**PLANNING BOARD RESOLUTION
VILLAGE OF MOUNT KISCO**

**NEGATIVE DECLARATION OF SIGNIFICANCE
SITE PLAN APPROVAL
WETLAND PERMIT**

**NY LUXURY MOTORS OF MOUNT KISCO (JAGUAR LAND ROVER DEALERSHIP)
299 KISCO AVENUE**

**Sheet 69.49, Block 2, Lot 1
Cal #2017-0350
November 24, 2020**

1 PARTIAL SITE PLAN
SP-3 RESULT 17-202

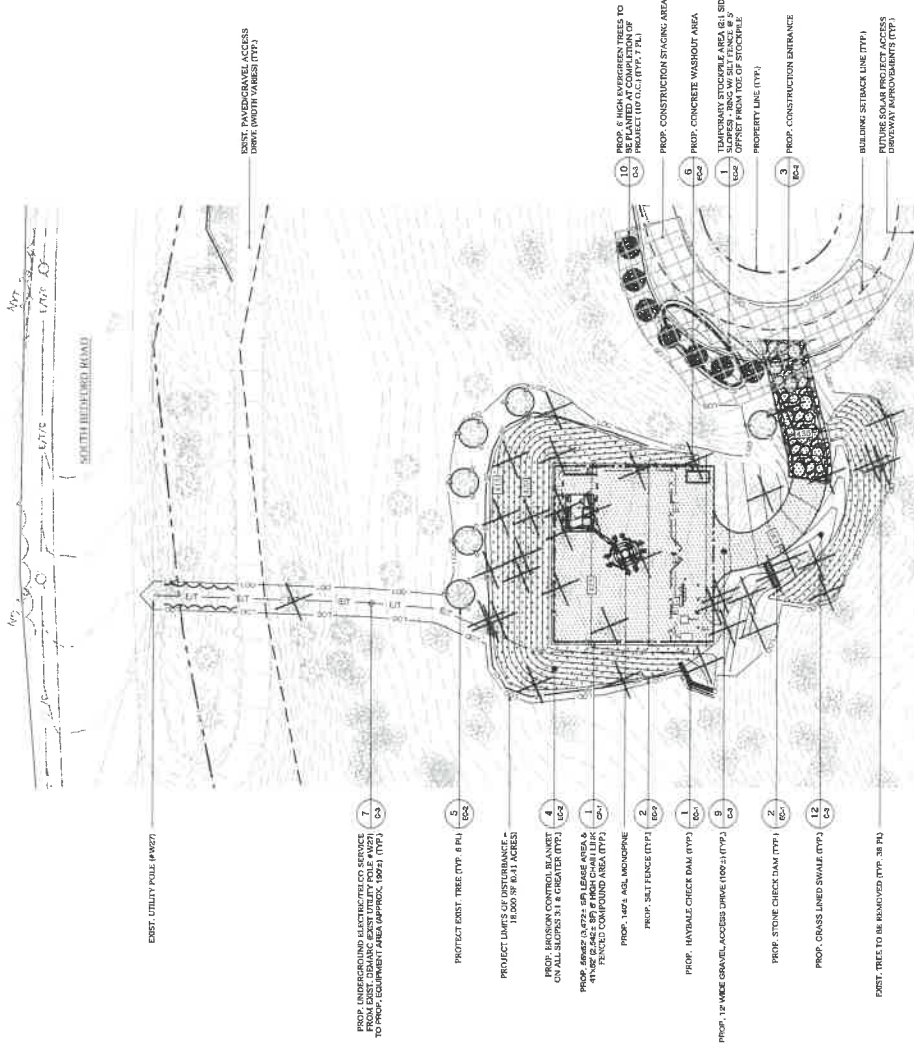
- Comment 2: Cut and fill calculations should be submitted for review.
The proposed earthwork numbers have been added to Drawing SP-3.
- Comment 6: The sediment and erosion control plan must provide greater detail and include items such as soil stockpiling, and a concrete washout location etc.
Additional sediment and erosion control detail has been added to Drawings SP-3, EC-1 and EC-2.
- Comment 7: The limit of disturbance should include any staging areas, it is unclear if other areas of the site would be utilized for this.
A proposed staging area has been added to the drawings and the proposed Limit of Disturbance has been increased to reflect this addition.

The stormwater calculations have been shown on Drawing SP-3. These calculations are based on the telecommunication installation only. The proposed solar panel project will be responsible for the stormwater for that facility. A SWPPP for the Telecommunications Facility has been included as part of the revised ZD submission (Drawing EC-1). We agree that NYSDEC General Permit coverage and NYCDEP SWPPP approval are required and will be sought once the design and layout of the facility are finalized by the Planning Board.

SHEET NUMBER:
A-3

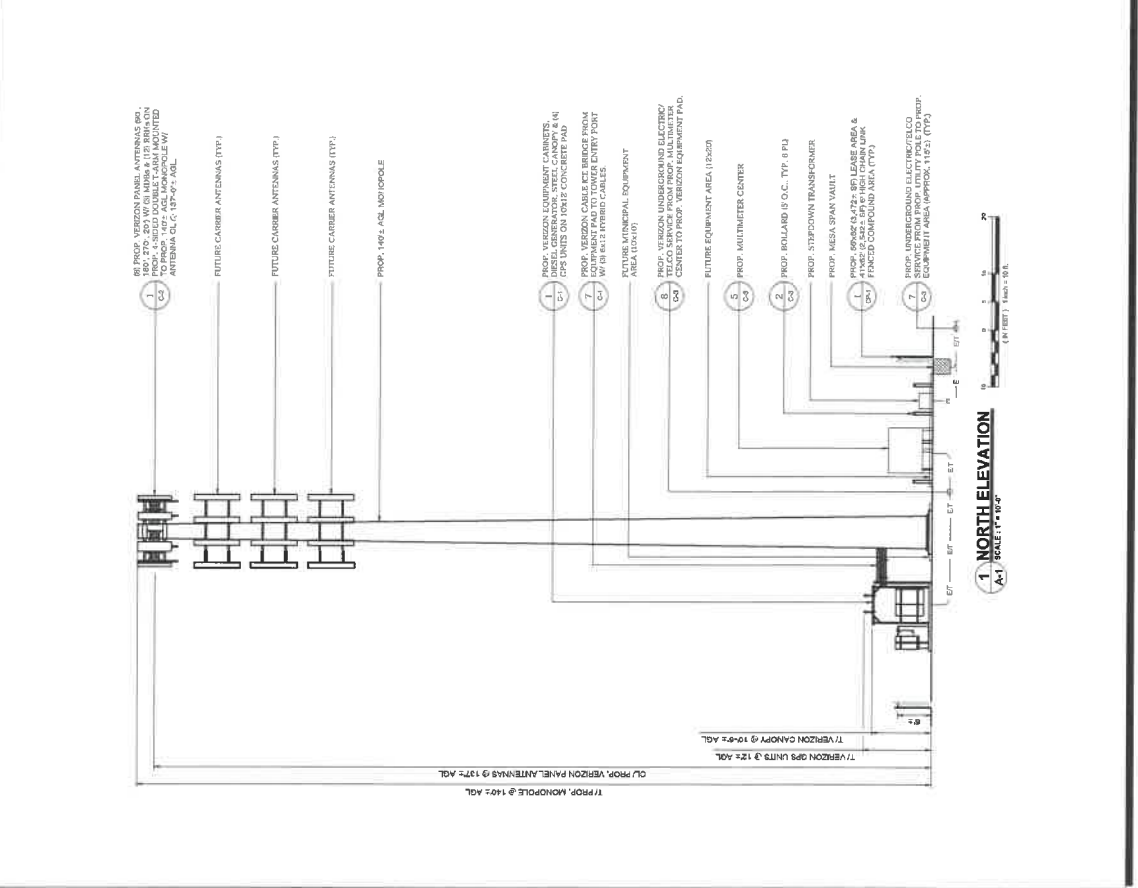
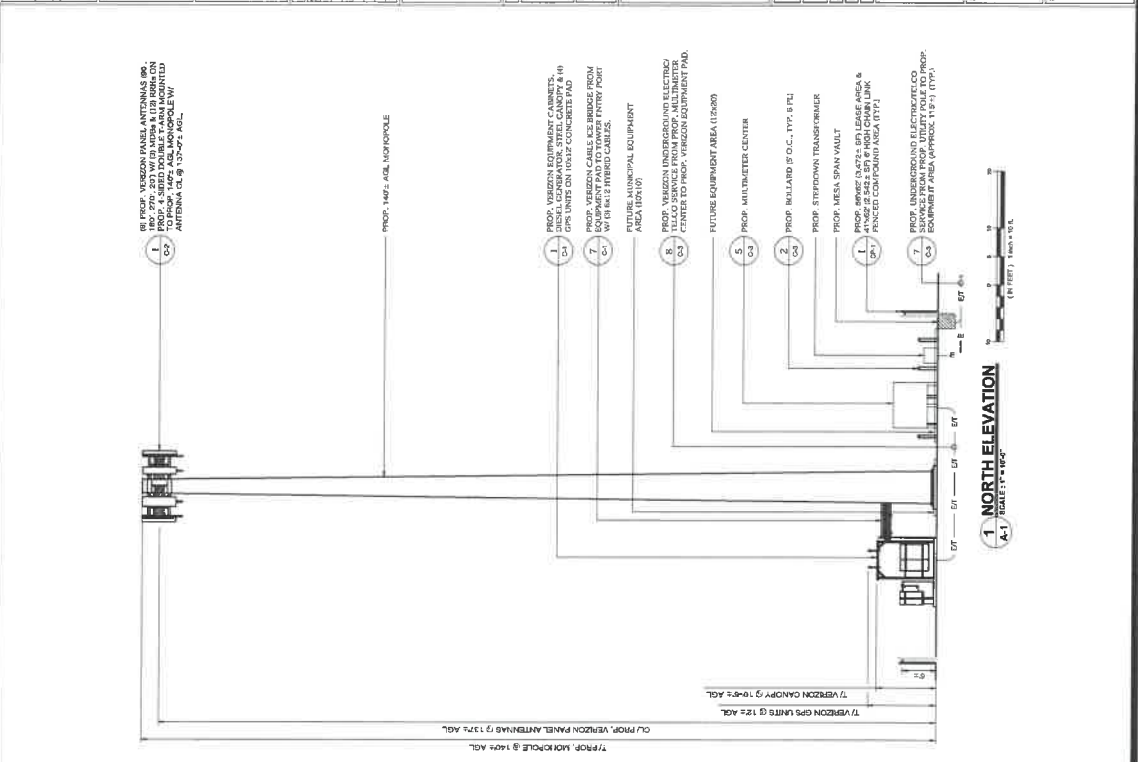
- Comment 16: Additional x-sections (DWGs A-1 and A-2) should be added to show a 140-ft conventional monopole, with and without co-location by other carriers. It is noted here and above that an alternate height scenario will need to undergo technical evaluation:
The two tower elevations described above have been added to Drawing A-3.
